APP Comments on CERC Staff Paper on Mechanism for Compensation for Competitively Bid Thermal Generating Stations for Change in Law on account of compliance of revised Emission Standards of MoEFCC

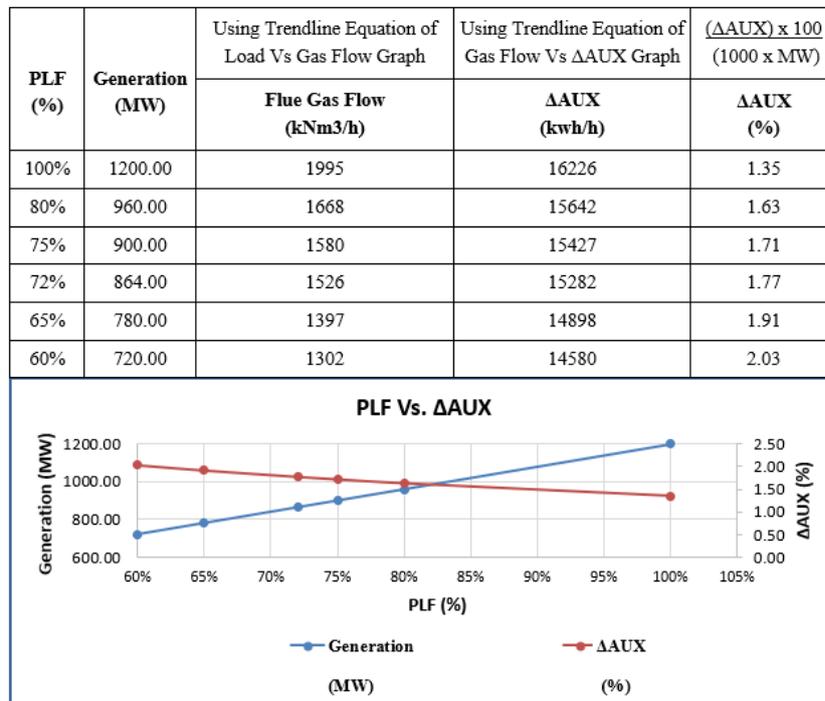
- a. We suggest that the Hon'ble Commission may allow Δ AUX upto 2% of gross generation, with an additional 0.5% Δ AUX for unit size of 210/250/300 MW or lower.

The Additional Auxiliary Energy Consumption (Δ AUX) for wet limestone based FGD system has been considered as 1% of gross generation, which in our view, appears to be low. These norms are on benchmark basis and do not consider plant specific requirements. Further, the power consumption of the desulfurization system is closely related to the parameters such as the amount of flue gas, the concentration of sulfur dioxide, the purity of limestone and the desulfurization efficiency, each unit is different and the prescribed limit of 1% of gross generation would fail to cover all these cases. Moreover, majority of wet limestone based FGD suppliers are quoting minimum auxiliary consumption of 1.2% at full load for unit size of 660 MW and even higher for for unit size of 300 MW and below.

Further, as per technical bids submitted by various OEMs for installation of Wet Limestone based FGD System, the Auxiliary Energy Consumption due to installation/ operation of Wet Limestone based FGD System has a negative/ inverse correlation with the flow of Flue Gas (i.e. Boiler Load, essentially PLF of the generating project) which shall be fed to the FGD system for removal of SO₂.

For a typical 1200 MW coal based thermal generation project, Flue Gas flow has been derived with respect to the PLF as per design calculations of the Boiler OEM and a graph has been

plotted for PLF (%), Generation (MW) and Δ AUX (%) as shown below, which clearly demonstrates an inverse correlation between Δ AUX and PLF and that Δ AUX shall vary in the range of 1.35% to 2% corresponding to the respective PLF range of 100% to 60%.

The above table and graph make it clear that the inverse correlation between AUX and PLF of TPPs should be factored in while framing the AUX norms. Considering the quotes provided by the equipment suppliers and the fact that average PLF of coal based thermal power plants are unlikely to rise significantly beyond 60%-65%, **we suggest that the Hon’ble Commission may allow Δ AUX upto 2% of gross generation, with an additional 0.5% Δ AUX for unit size of 210/250/300 MW or lower.**
